# **DOROTHY LEE SUBDIVISION, RESUBDIVISION** **OF**

APPLICATION NUMBER 15 DATE November 6, 2003  
APPLICANT Dorothy Lee Subdivision, Resubdivision of  
REQUEST Subdivision

# DOROTHY LEE SUBDIVISION, RESUBDIVISION OF

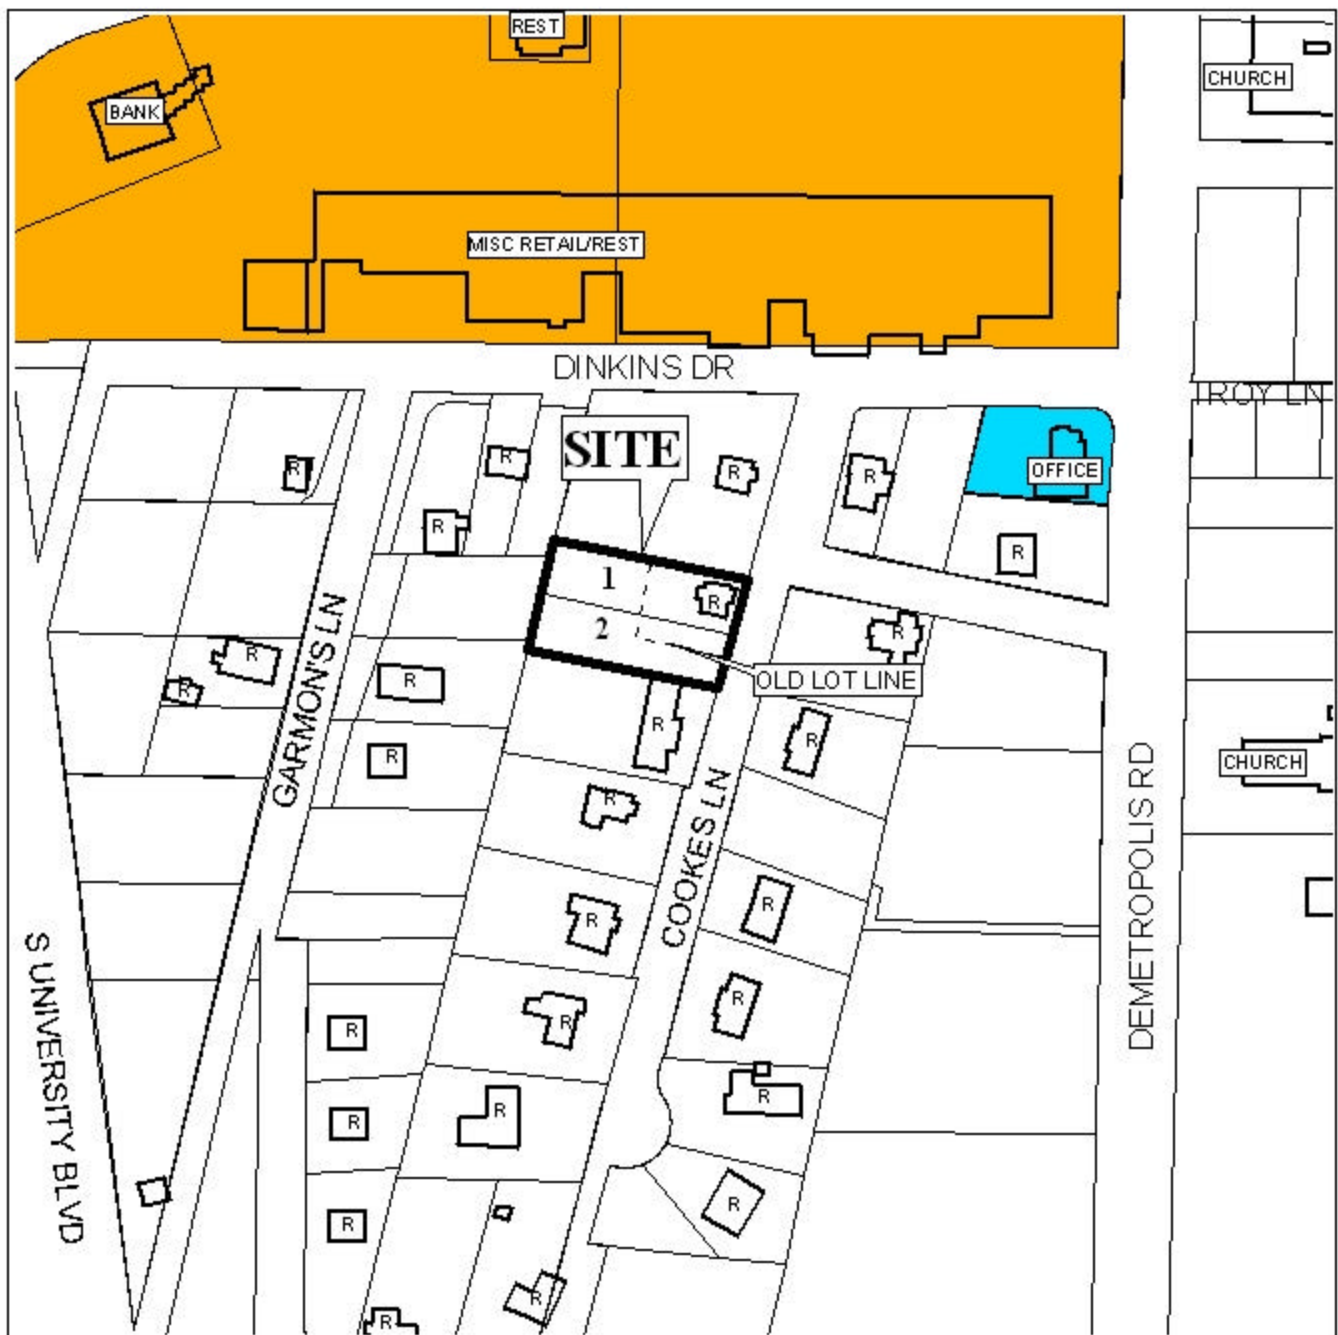
One of the existing lots is a flag-shaped lot; the proposed plat would create two typical shaped lots. While the two lots would not comply with Section V.D.3. (width to depth) the proposed configuration of lots would be more in keeping with the development of the surrounding area.

With a waiver of Section V.D.3., the plat meets the minimum requirements of the Subdivision Regulations and is recommended for Tentative Approval.
